VIRGINIA ELECTRIC AND POWER COMPANY  
RICHMOND, VIRGINIA 23261

Serial No. 725A  
NO/WLT/JOE:ms  
Docket No. 60-338  
License No. NPF-4

REQUEST FOR ADDITIONAL INFORMATION  
ELECTRICAL DISTRIBUTION SYSTEM VOLTAGES  
NORTH ANNA POWER STATION

ATTACHMENT "A"

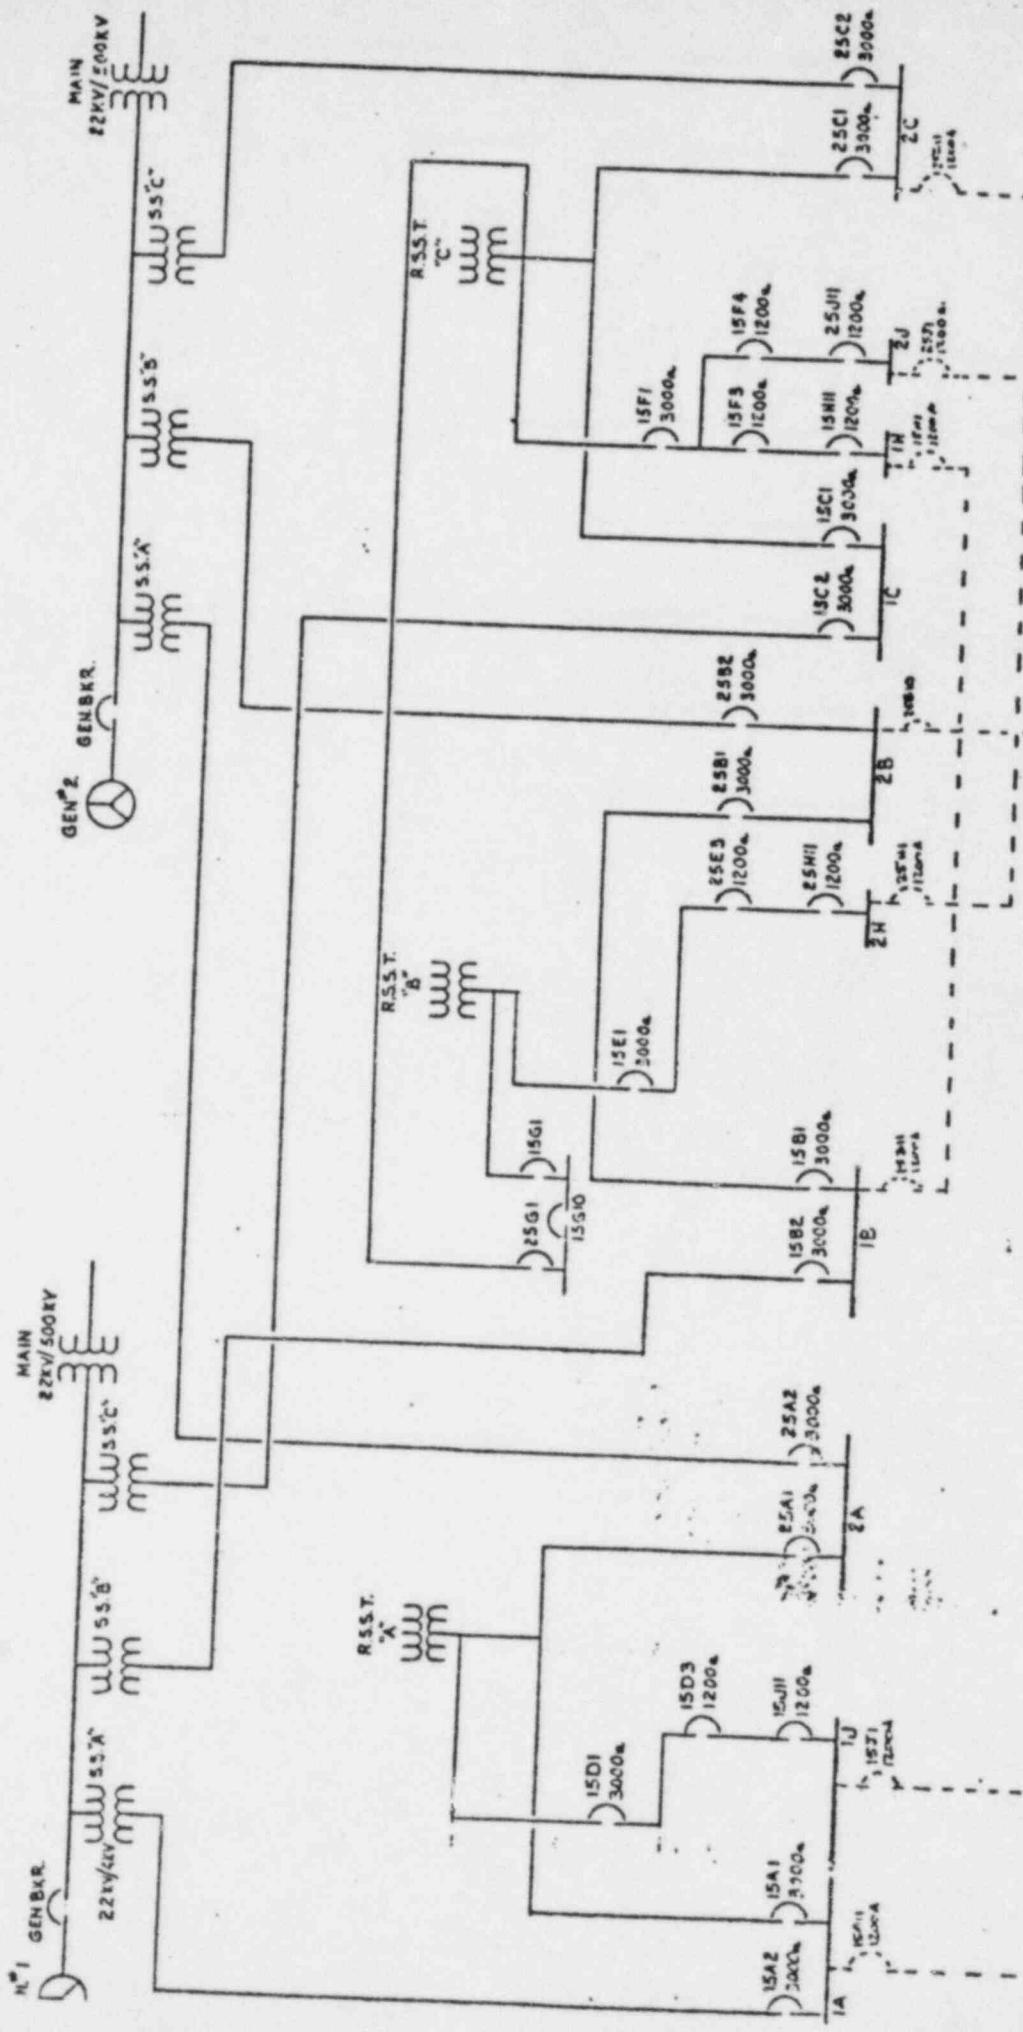
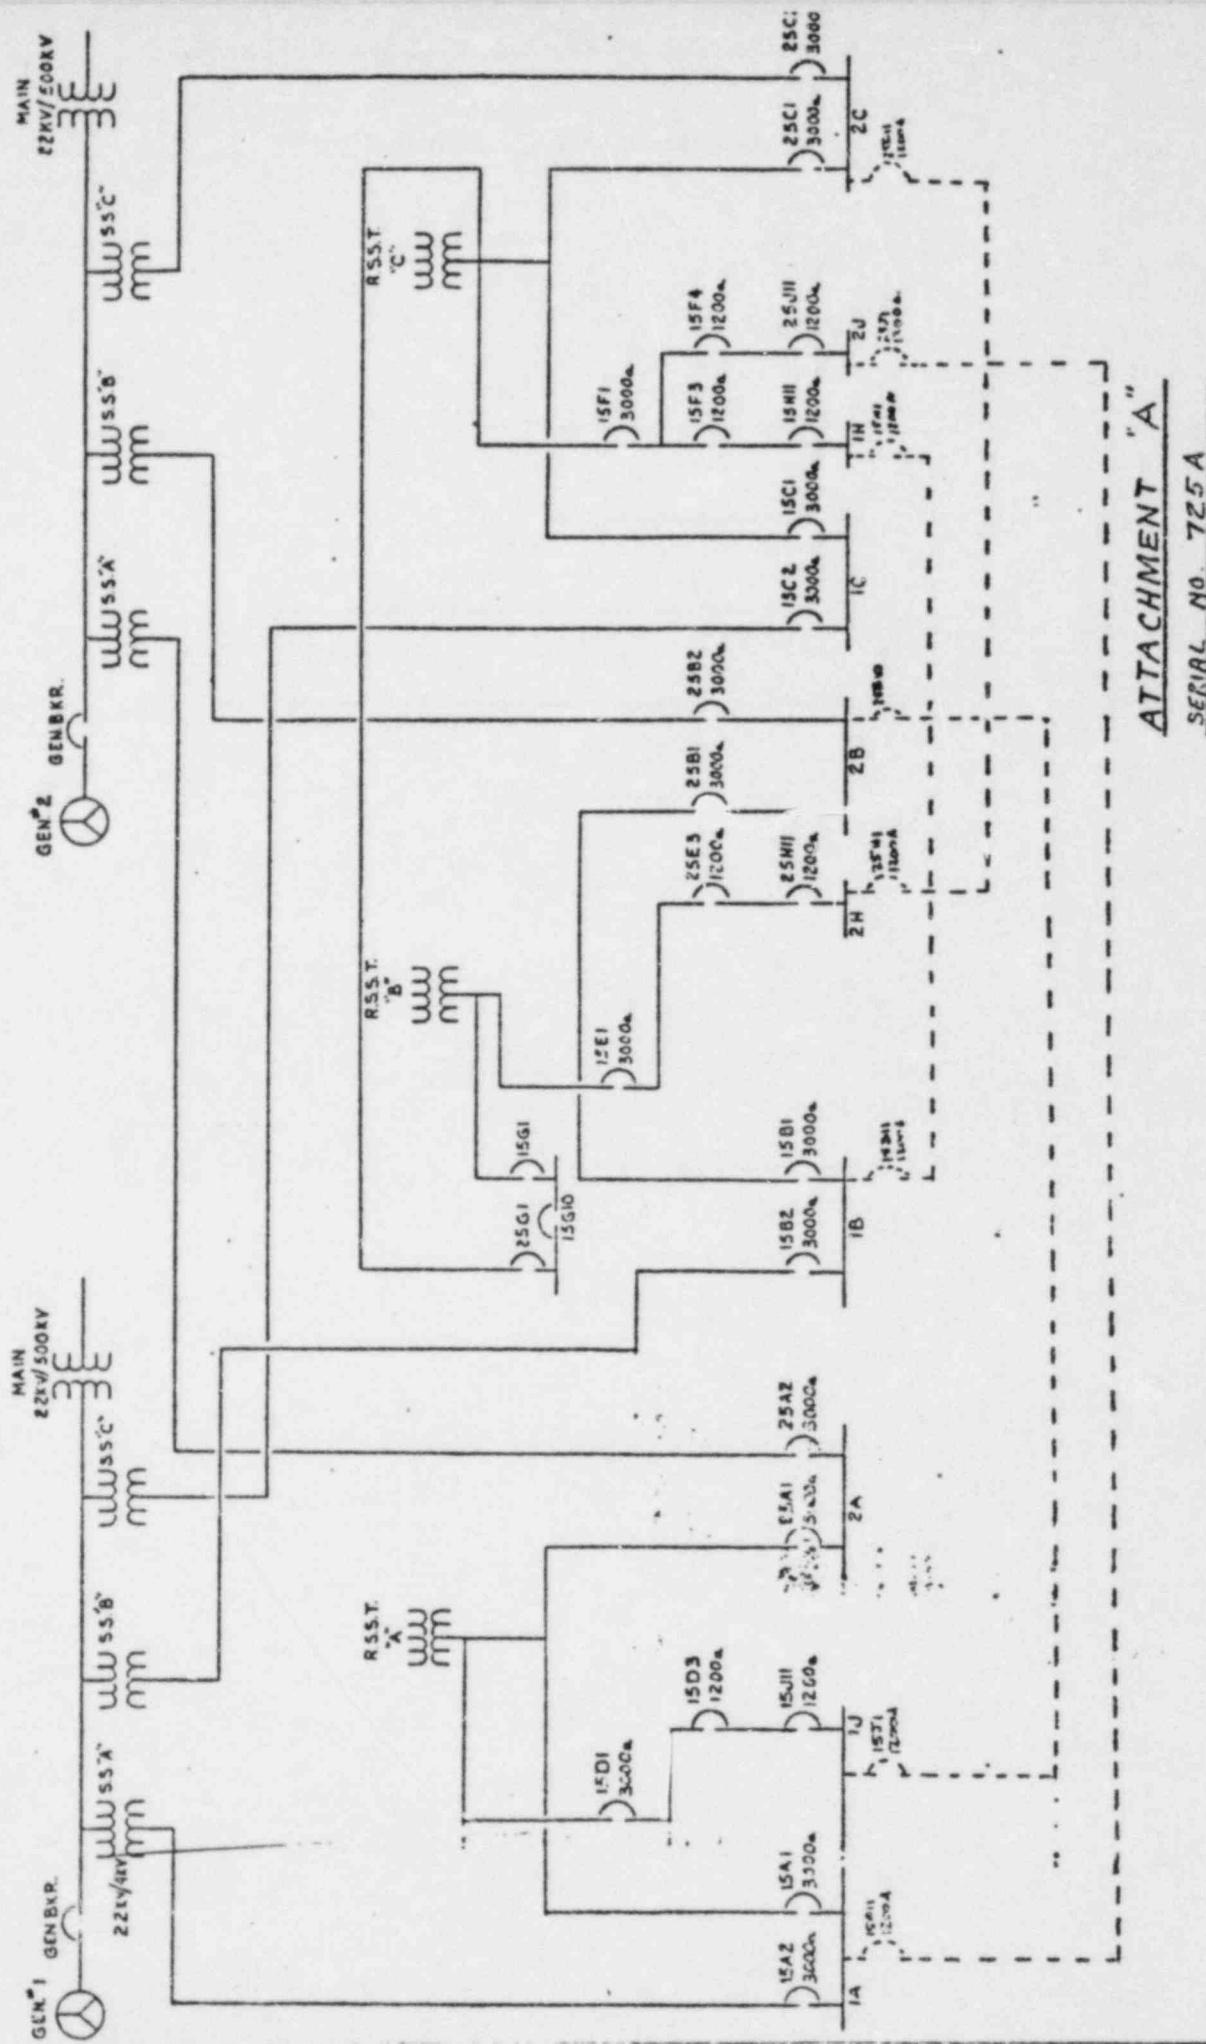
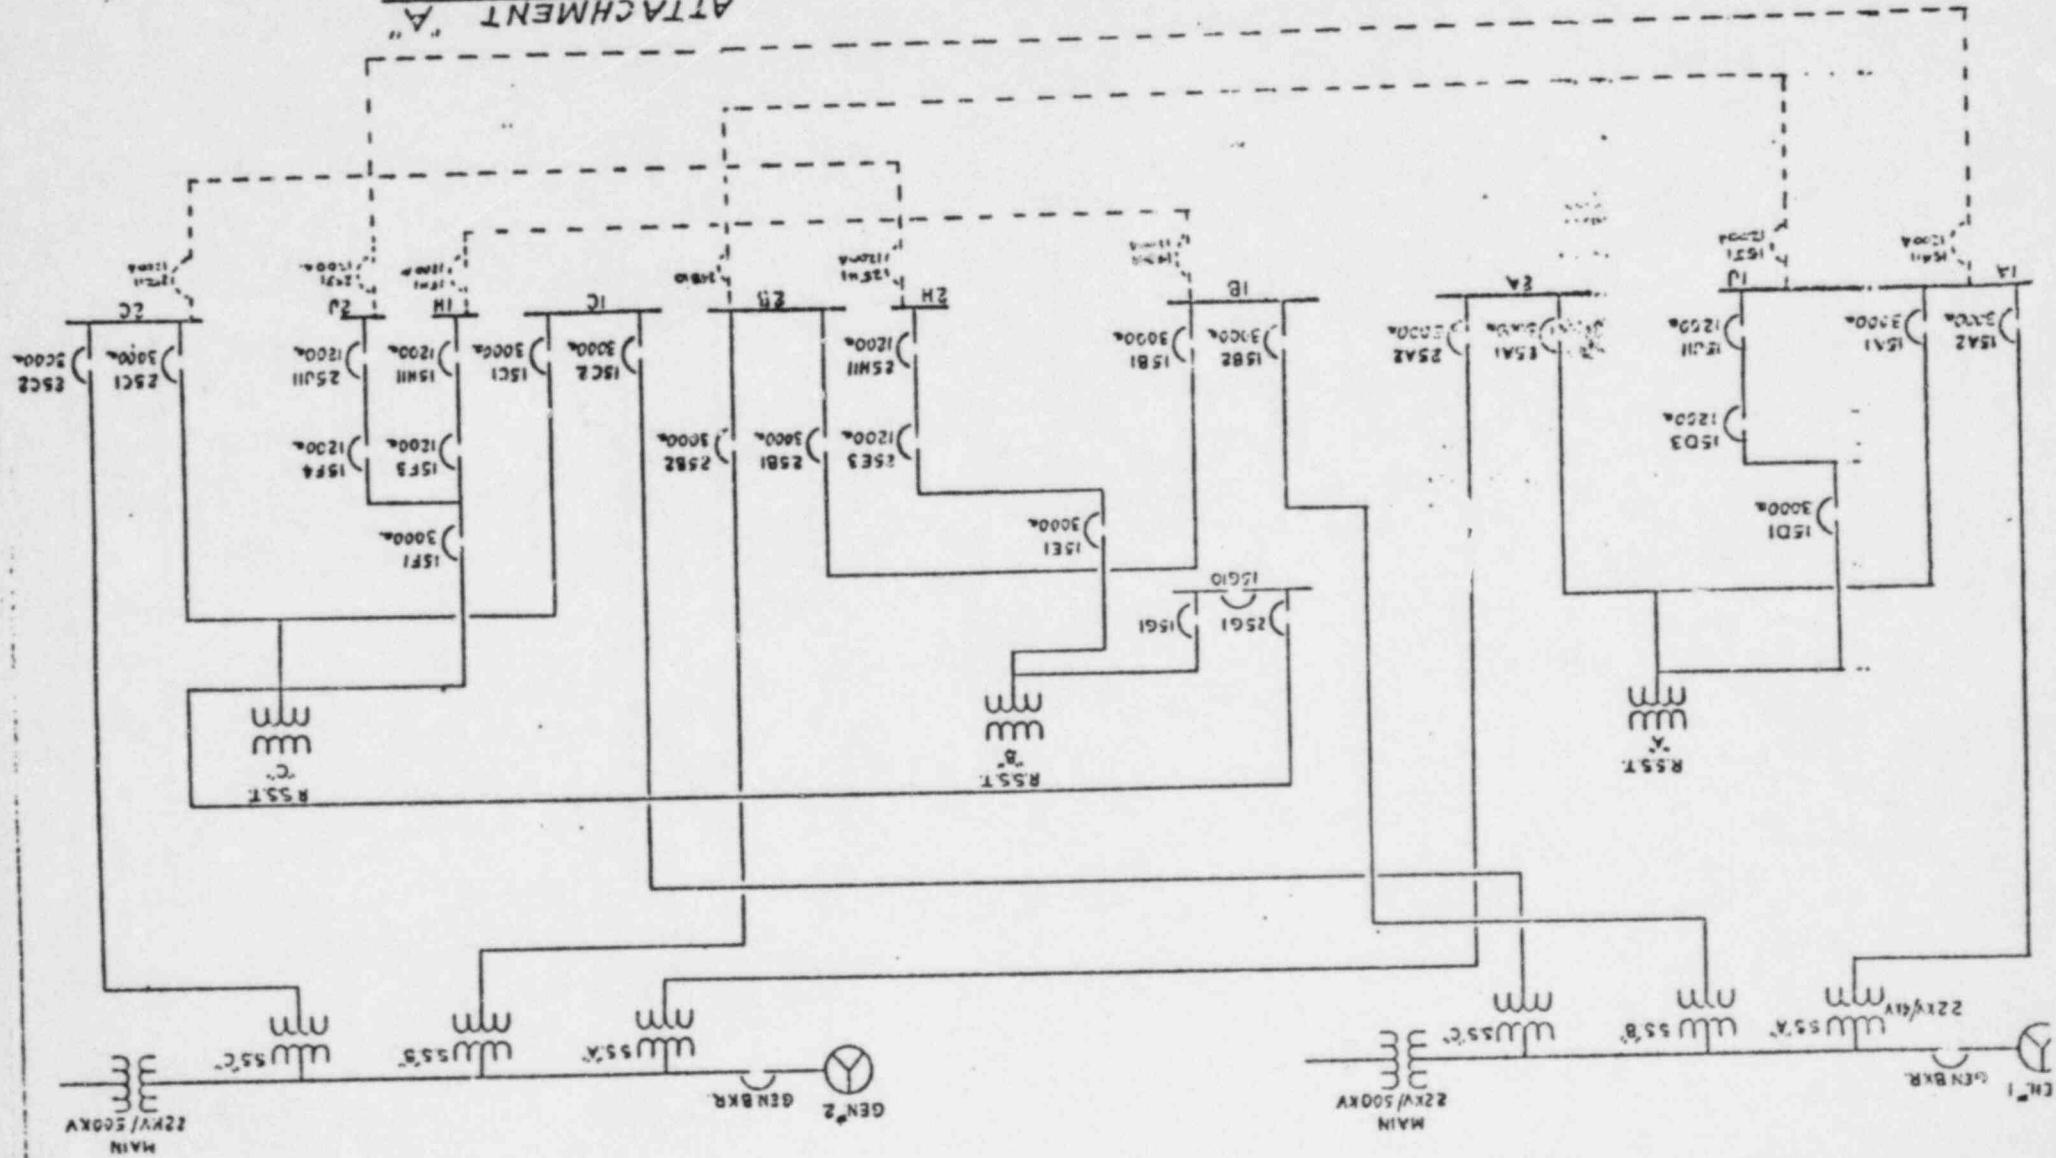
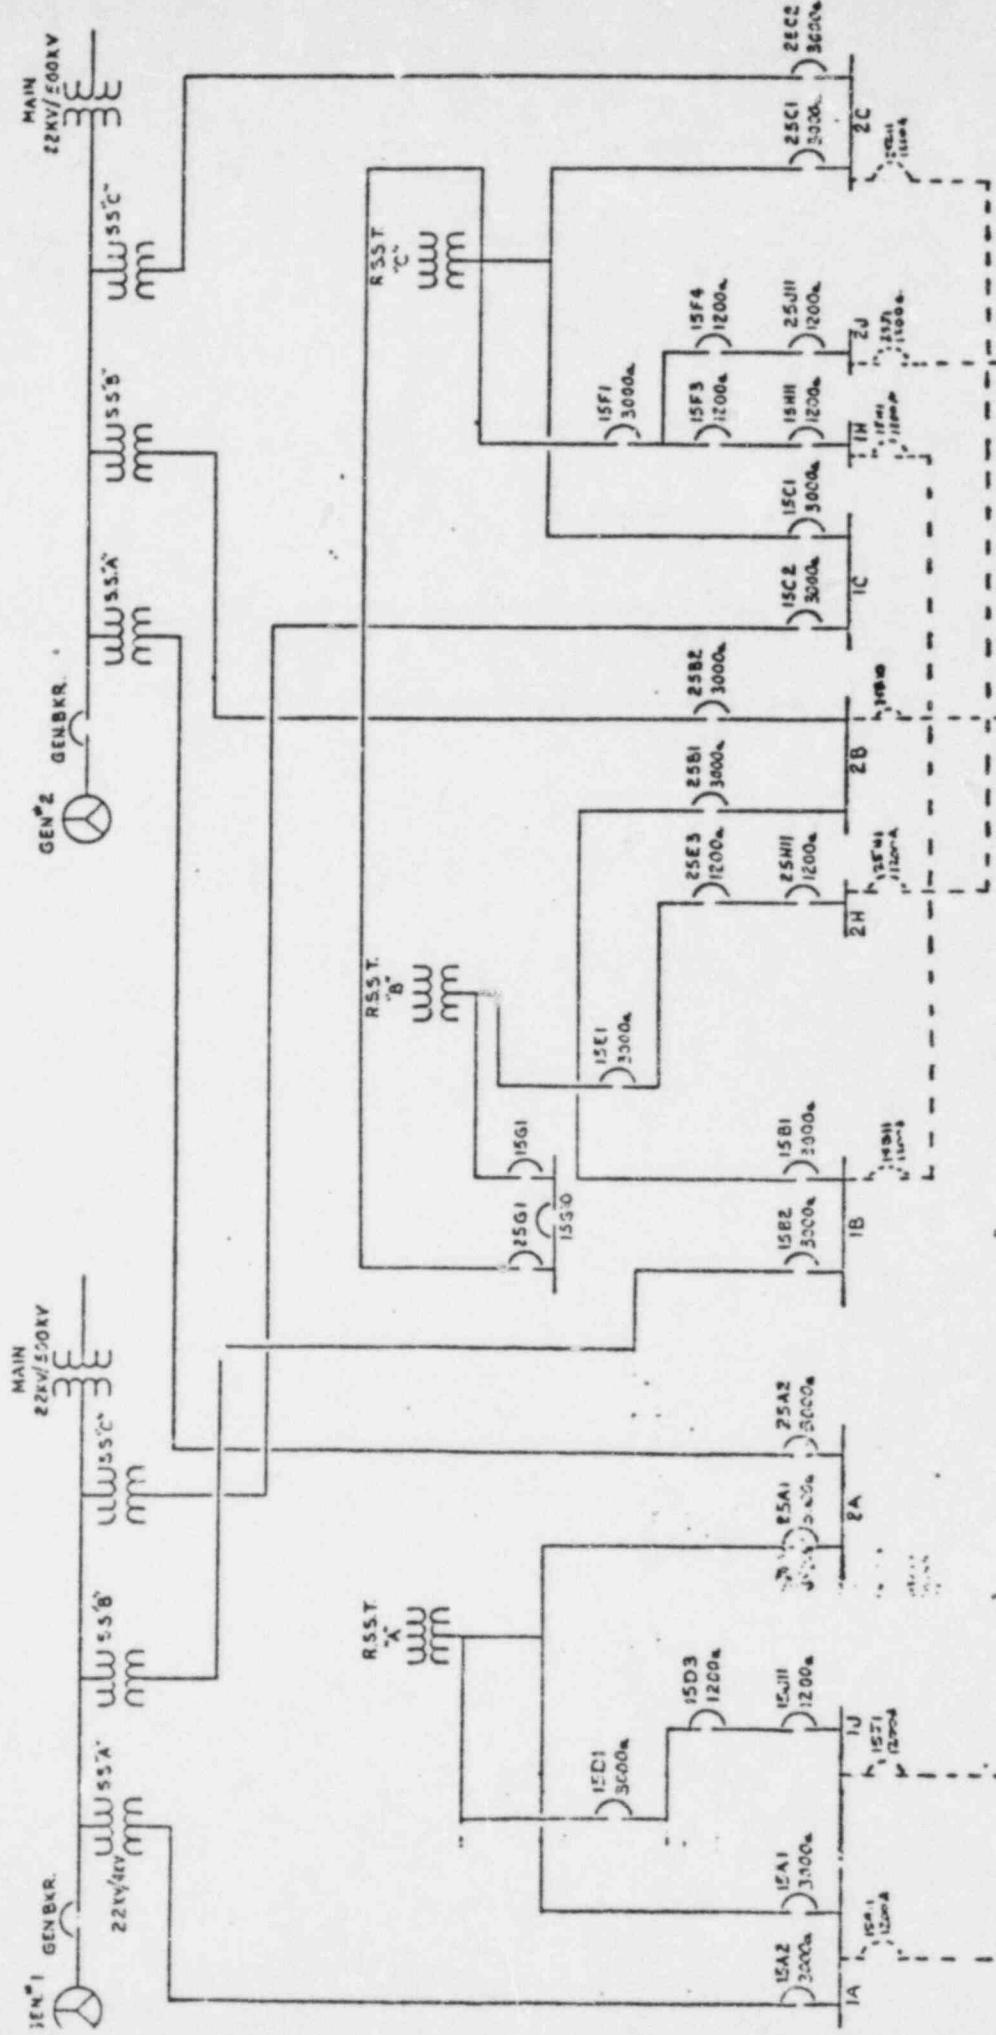
Our analysis has shown that the installation of circuit breakers between the generator and the station service transformers will provide tremendous flexibility and capability in offsite power supplies. Attachment A to this letter is a one-line diagram of our planned future system. This arrangement will allow unit start-up with auxiliaries powered through the normal station service transformers. It will also curtail the need to transfer auxiliary loads to the reserve transformers for most unit trips. Therefore, it will be inconceivable that the loading on the reserve system could ever approach the postulated values in our previous studies.

One additional benefit of the generator breaker would be that it provides an additional offsite power supply through the main transformer and the station service transformers. By installing a generator breaker in each unit at North Anna, we will have four independent power supplies from the 500KV bus to the two units' auxiliaries. This advantage will be utilized by providing an alternate tie to each 4KV emergency bus from a normal station service bus.

The design for the modifications discussed above for North Anna Units 1 and 2 is proceeding. Installation will occur at the earliest practical date. Further information on this modification will be forwarded to you in a later submittal.
